**City of Portland, Maine - Building or Use Permit Application**

<b>Proposed Project Description:</b> install a direct vent natural gas heater
--	--

Subject: Roof Framing Evaluation, Brockway Smith Warehouse, Portland, Maine

SECTION ①  
 NTS

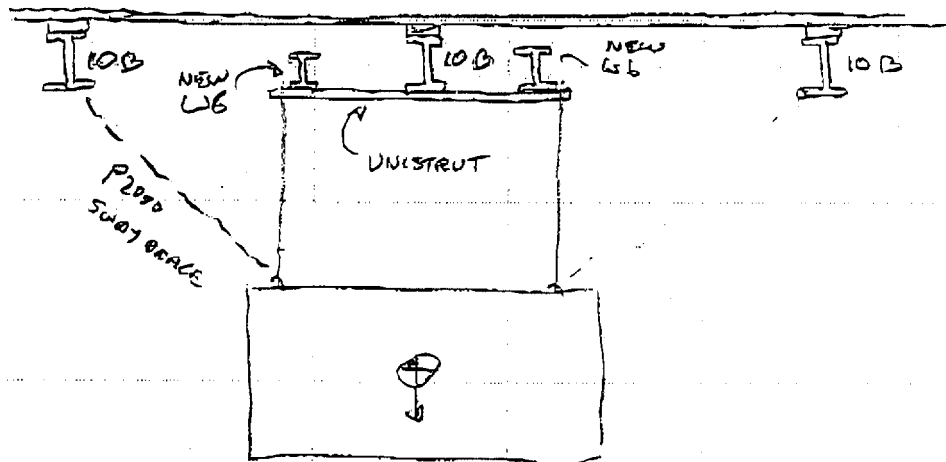
Although the HVAC units add only approximately 1 psf, or 2%, to the tributary area of any particular beam, the fact that the beams are already slightly under the required capacity prevents me from recommending a support structure that includes the existing 10" roof beams. I recommend adding two 6" **beams** at each unit to **support** the weight of the unit. I have included sketches detailing how this could be accomplished. The beams can be fabricated in a number of smaller pieces to facilitate the installation around existing mechanical and electrical interferences.

It should be noted that current building codes require seismic bracing for suspended mechanical equipment. For this building, the predicted lateral seismic loads are approximately 12% of the unit weight. A piece of Unistrut Series P2000 channel as a diagonal brace in each direction *is* called for **and** shown on the sketches.

PARTIAL PLAN  
YB = 1'-0"

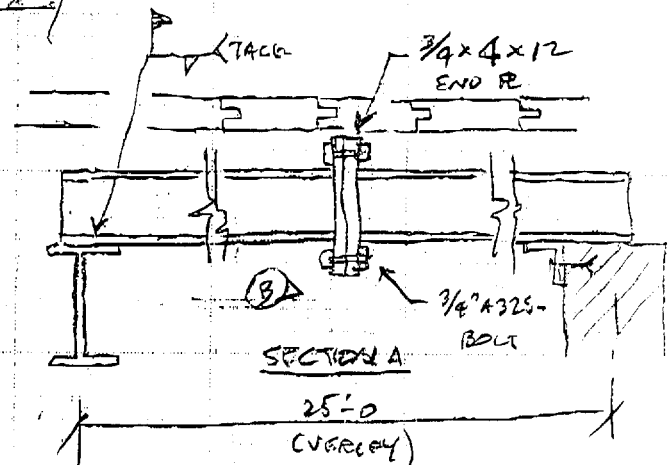
NOTES: 1. LOCATE UNITS @ COLUMN LINES  
2. SPLICE BEAMS AS NECESSARY TO CLEAR UTILITIES

$W = 63 \times 6.25 = 394$   
 $M = 394 \times 25^2 / 8 = 30.8$   
 $f_b = 22.8 \quad (10B17)$   
 $f_b = 2 \quad ( )$   
 $F_{allow} = .66 \times 33 = 21.8$

USE W6x9  $f_b = 7.5 < F_b$  ok.  
 $F_b = 57.4$   
 (2)
